RE: STATE SIGNIFICANT DEVELOPMENT APPLICATION (SSD 9522) FOR PROPOSED WAREHOUSE, LOGISTICS AND INDUSTRIAL FACILITIES HUB

PROPERTY AT: 657-769 MAMRE ROAD, KEMPS CREEK (LOT 34 DP 1118173, LOT X DP 421633, LOT 1 DP 1018318, LOT Y DP 421633 & LOT 22 DP 258414)

Table 1: Response Matrix

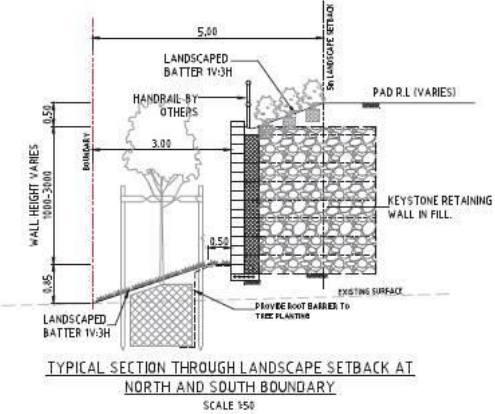
5.	<p><i>The southern boundary adjoins industrial and an RE1 public recreation zone. A retaining wall up to 3.2m is proposed along the southern boundary of the development, which would compromise the amenity of the RE1 land.</i></p> <p><i>Consideration should be given to reducing the height of the retaining wall where possible, setting the retaining wall back from the property boundary to allow for landscaping and tree canopy and stepping the retaining wall with sufficient deep soil zones for landscaping.</i></p>	<p>The height of filling is required to facilitate stormwater drainage, detention and water quality; however, to reduce impacts to the south a 3m landscape screening approach has been implemented in front of the retaining walls which will allow for mature trees and vegetation to screen the retaining wall. A further 2 m has been provided at the top of the wall to screen the building toward the south. This is consistent with the submitted Civil Engineering Drawings submitted as part of the RtS submission.</p> <p>Reference to Section C-C on the revised Landscape Plans detailed in Appendix 7 of this Submission illustrates where Habit8 has updated Section C-C demonstrating adequate screening of the 3 m retaining walls along the southern boundary of the Site.</p>
